# NORTHWATCH

June 4th, 2013

Dr. Stella Swanson, Panel Chair  
Dr. James F. Archibald, Panel Member  
Dr. Gunter Muecke, Panel Member  
Deep Geologic Repository Project Joint Review Panel  
Canadian Environmental Assessment Agency  
160 Elgin St., 22nd Floor, Ottawa ON K1A 0H3

**Information Requests and Responses Related to  
Decommissioning Wastes  
IR Packages 1-10  
2012 – May, 2013**

IR#	EIS Guidelines Section	Information Request and Response																
		<p data-bbox="516 262 945 283">Figure 1: Breakdown of 204,000 m<sup>3</sup> Total DGR Waste Volume by Origin</p>

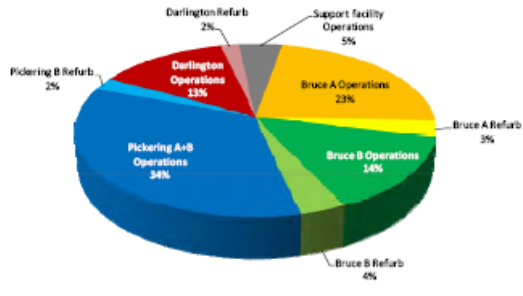
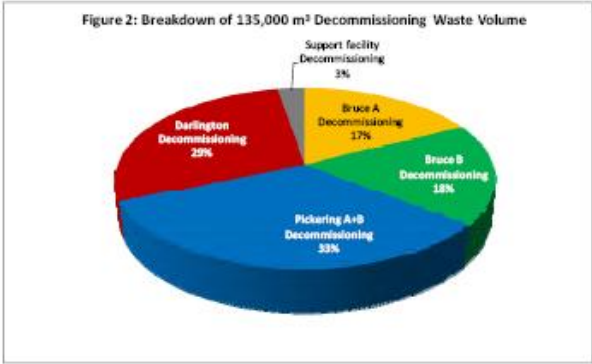
*Provide a specific break down of waste volumes per reactor and per activity, in the form of a pie chart. Identify whether any decommissioning waste is in the current proposed project description.*

*It is not evident if the amount of 21,000 m<sup>3</sup> is the waste generated from each of the 16 reactors ( 20 minus 4 at Pickering B) or a combined amount for all ongoing and possibly planned refurbishments. Also, on the page 3-4, OPG states that, "in the future, an additional approximately 135,000 m<sup>3</sup> of L&ILW is expected to be produced during the decommissioning of the [20] reactors and the associated nuclear waste storage facilities." The next sentence reads: "The currently proposed DGR Project does not include management of decommissioning waste".*

As documented in the DGR reference inventory report (OPG 2010, Tables 2.1 and 3.1), the amount of waste to be placed in the DGR within the scope of the application is approximately 182,300 m<sup>3</sup> of "operational" low and intermediate level waste plus 21,700 m<sup>3</sup> of "refurbishment" low and intermediate level waste, for a total of 204,000 m<sup>3</sup>. This represents the total of all as-packaged waste from OPG owned or operated reactors for emplacement in the DGR, and uses the radiologically-conservative assumption that all reactors except for Pickering A are refurbished for continued operation. (In this context, radiologically-conservative" means maximizing the radionuclide inventory of the waste for postclosure safety assessment purposes.)

The breakdown of the 204,000 m<sup>3</sup> by station and activity is given in Figure 1 below. The "operational" waste includes both the pre- and post-refurbishment periods. The OPG owned or operated support facilities include the waste management facilities at the Pickering, Darlington, and Bruce sites; and the Darlington Tritium Removal Facility, health physics labs, the Central Maintenance and Laundry Facility at the Bruce nuclear site, and other similar facilities required to directly support the operation of the nuclear generating stations.

In addition to this, approximately 135,000 m<sup>3</sup> of decommissioning low and intermediate level waste is expected to be generated in the future. As reported previously in OPG's response to Information Request EIS-04-102 (OPG 2012), this is not included in the current DGR project scope inventory. However, it is identified in the Cumulative Effects Assessment in the Environmental Impact Statement (OPG 2011, Section 10.4.1) as a "reasonably foreseeable" future project. As shown below in Figure 2, the 135,000 m<sup>3</sup> of decommissioning waste can be allocated as approximately 17% Bruce A, 18% Bruce B, 33% Pickering A + B, 29% Darlington, and the remaining 3% for the miscellaneous support facilities.
